# Local Planning Panel

19-21 Buckland Street, Chippendale

D/2022/1359

# Proposal

north/south section

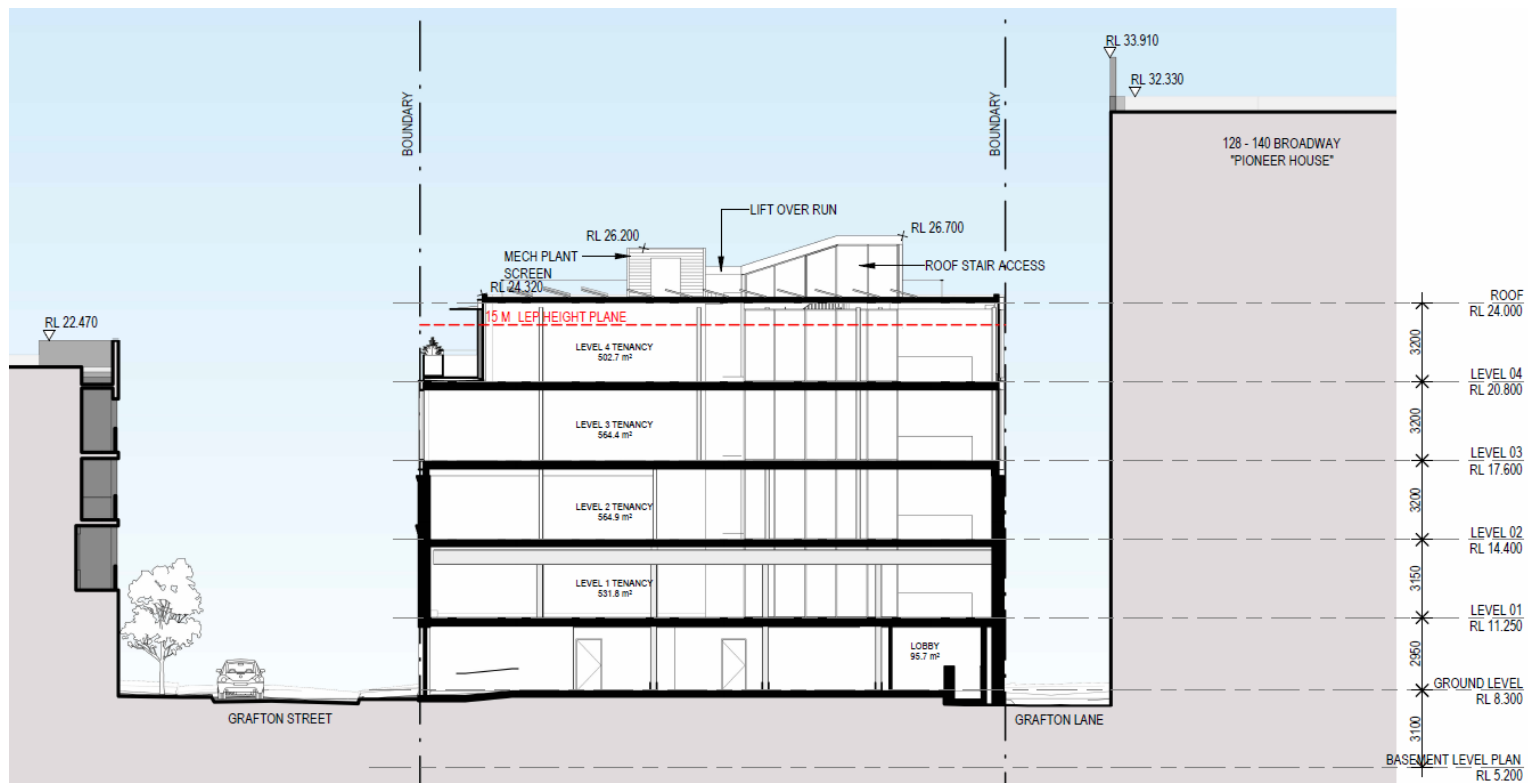
- exceeds height standard by 3.75m (24.9%)
- non-compliance arises from upper portion of top floor, lift over run, plant and roof access stair
- non-compliance does not result in significant adverse impact
- built form appropriate to context
- Complies with FSR
- Clause 4.6 variation request supported

proposed height exceedance

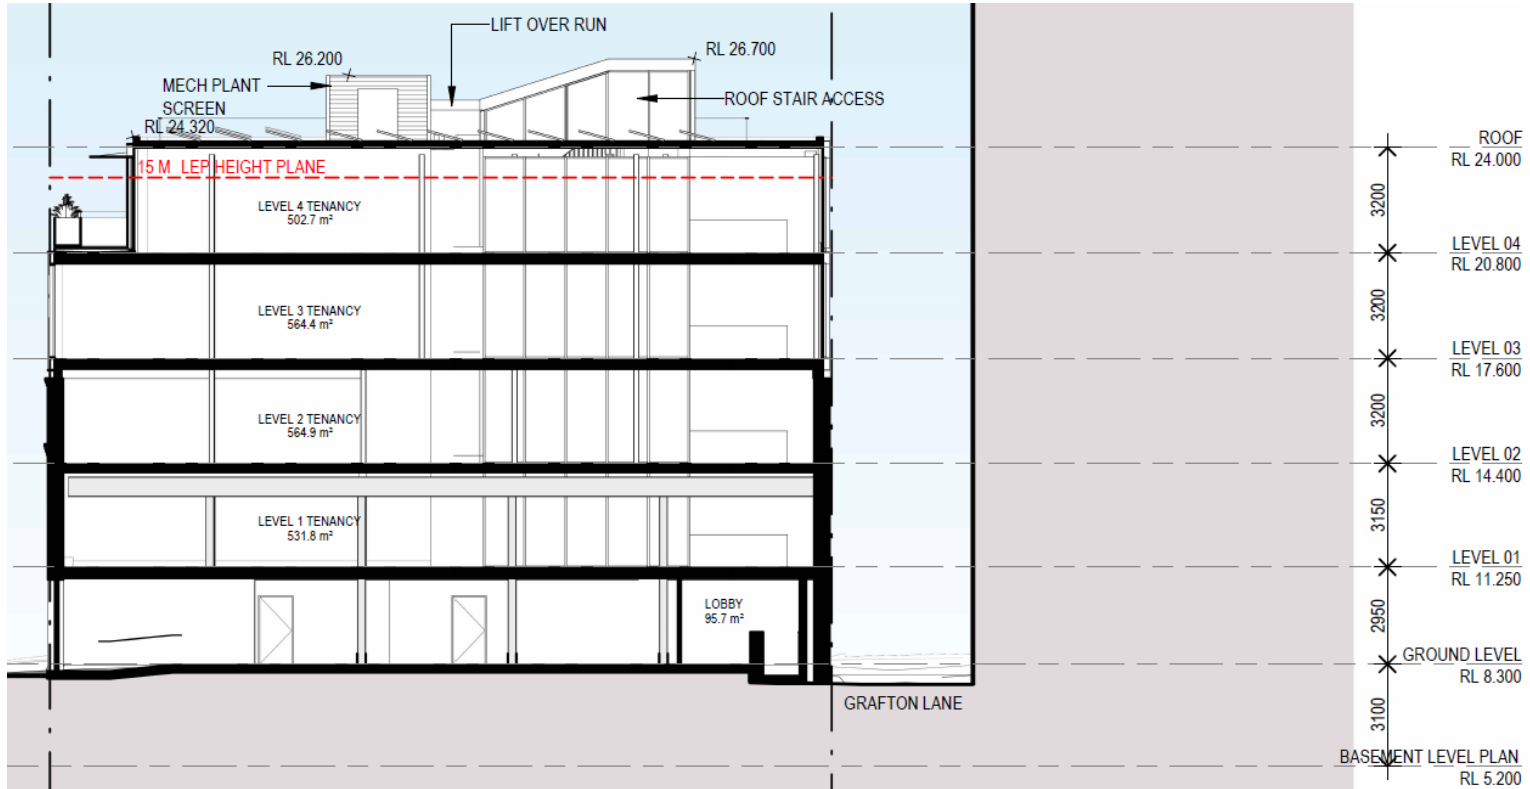
- ground floor and first floor height constrained by existing window openings in the retained facade and retained structural beams
- floor to floor heights increase to 3.2m on introduced floors (levels 2 - 4)
